PCB ISSUE EF	USED ON	SL678	A2
TITLE	ULTIMATION		
	4 CHANNEL BUSCARD		
DRG.NO.	T82359.71		
SHEET	1 OF 1		
Solid State Logic

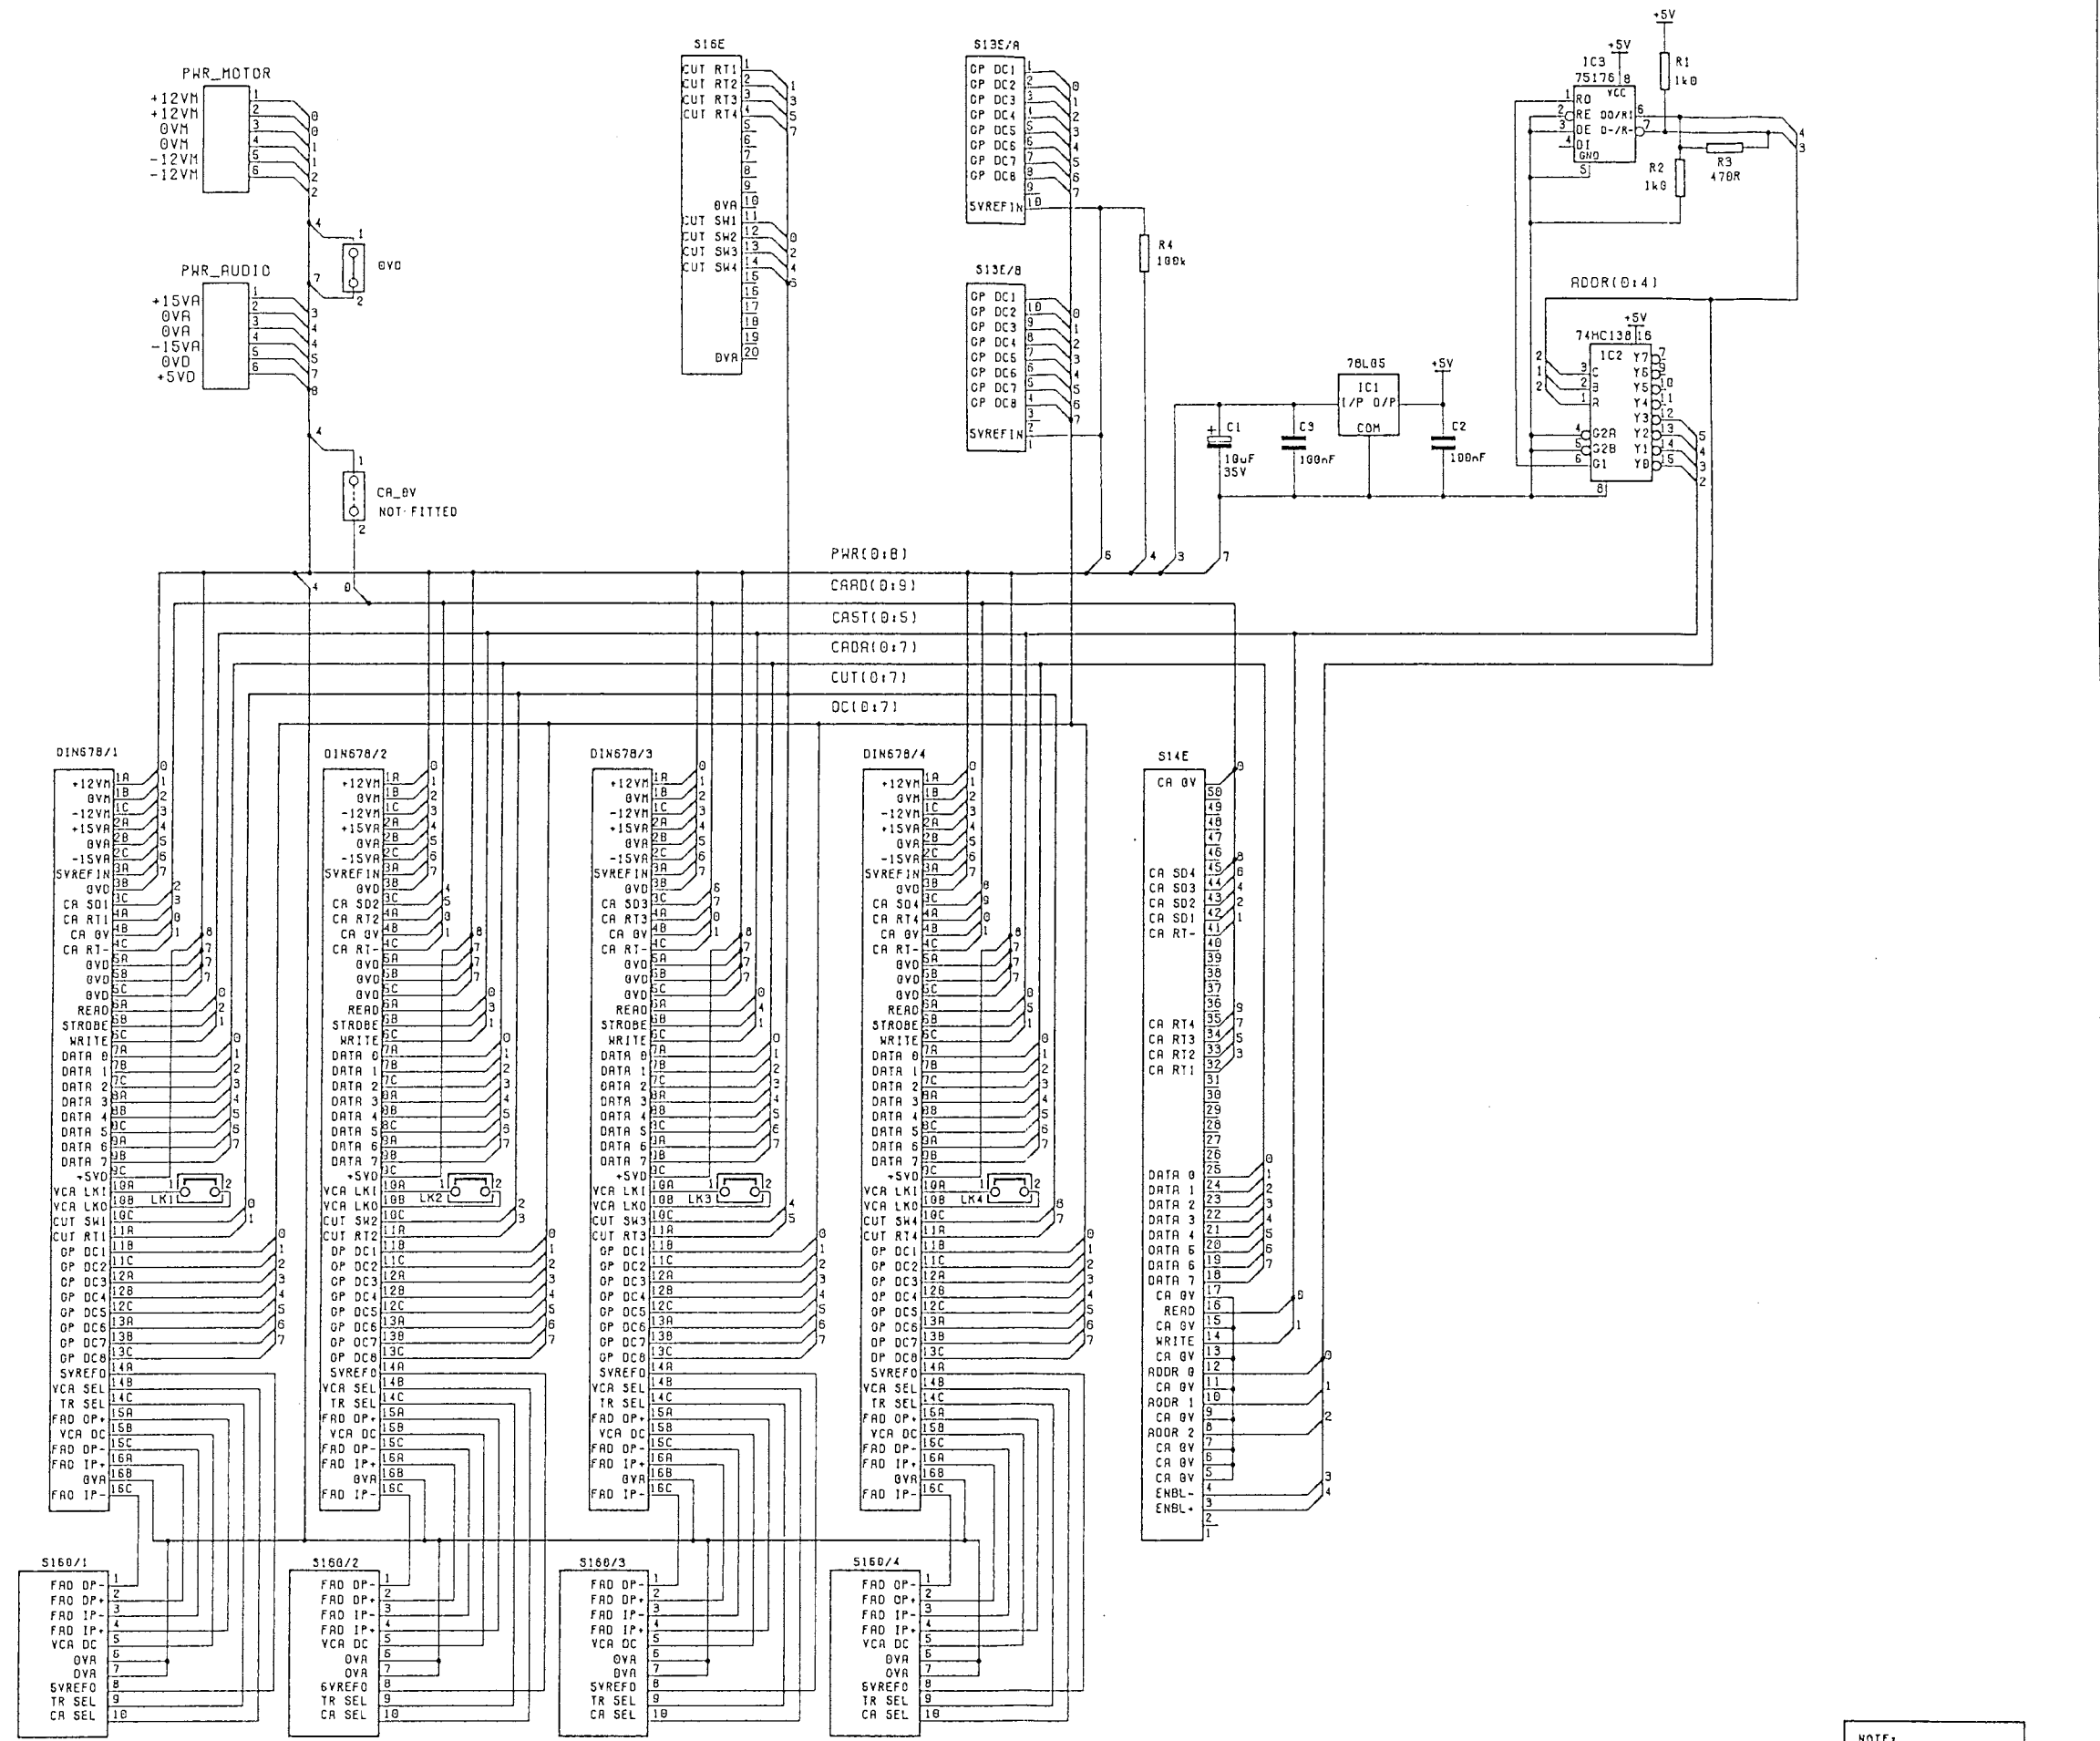
REV	ISS	DATE	DETAILS	
0	A	27 MAR 91	NEW DRAWING	BC
1	A	8 MAY 92	ECO 4K/955 R1 R2 WERE 10K NOW 1K	MM
2	A	12 NOV 92	ECO 4K/1057, R3 WAS 100R NOW 470R	MM
